## **Access Compliance Report Public Rights-of-Way** (Curb Ramps)

Intersection ID: 10029454 Main Street: KENILWORTH AV **Cross Street: N/A** Location: NE **ADA ID: FCE0BEB594EE** Ramp Type: PerpDiag Initial Pass/Fail: Fail **Overall Compliance: No** Severity Score: 33.75

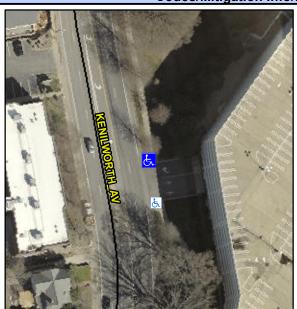
Possible Solutions: Remove & Replace Curb Ramp With **Two New Directional Ramps or** Equivalent. Surveyor Notes: N/A PROW/ADA: Not Found, R304.5.1, R304.5.3

Field Measurements/Component Compliance					
Compliance Description		Data	Comp	liance Description	Data
N/A	Ramp Length (in)	79.0	Yes	Ramp Slope (%)	5.9
No	Ramp Width (in)	47.0	No	Ramp XSlope (%)	8.9
N/A	Flare Type LT	N/A	N/A	Flare Type RT	N/A
N/A	Flare Slope LT (%)	N/A	N/A	Flare Slope RT (%)	N/A
N/A	Flare Traversable LT?	N/A	N/A	Flare Traversable RT?	N/A
N/A	Landing Length (in)	N/A	N/A	DWS Provided?	N/A
N/A	Landing Width (in)	N/A	N/A	DWS Contrast?	N/A
N/A	Landing Slope (%)	N/A	N/A	DWS Length (in)	N/A
N/A	Landing X Slope (%)	N/A	N/A	DWS Full Width?	N/A
N/A	Landing Curb? (Y/N)	N/A	N/A	DWS Offset (in)	N/A
N/A	Shared Landing?	N/A			
N/A	Gutter Ponding?	N/A	N/A	Gutter Slope (%)	N/A
N/A	Gutter Lip Ht (in)	N/A	N/A	Gutter X Slope (%)	N/A
N/A	Painted X Walk1?	No	N/A	Painted X Walk2?	No
	X Walk 1 Direction	To W		X Walk 2 Direction	To S
N/A	X Walk 1 Width (in)	N/A	N/A	X Walk 2 Width (in)	N/A
	X Walk 1 Slope (%)	3.9		X Walk 2 Slope (%)	3.1

X Walk 1 X Slope (%)	1.3		X Walk 2 X Slope (%)	5.9
N/A	Ramp inside XWalk1?	N/A	N/A	Ramp inside XWalk2?	N/A
	Road Slope (%)	6.1	N/A	Clear Space?	N/A
	Road X Slope (%)	8.1	N/A	Clear Space to XWalk (in)	N/A
N/A	Any Obstructions?	N/A	N/A	Storm Grate/Utility Hazard?	N/A
	Obstruction Type			Storm Grate/Utility Type	
		N/A			N/A
			Yes	Surface Condition? (G/P)	Good
	THE ROLL OF
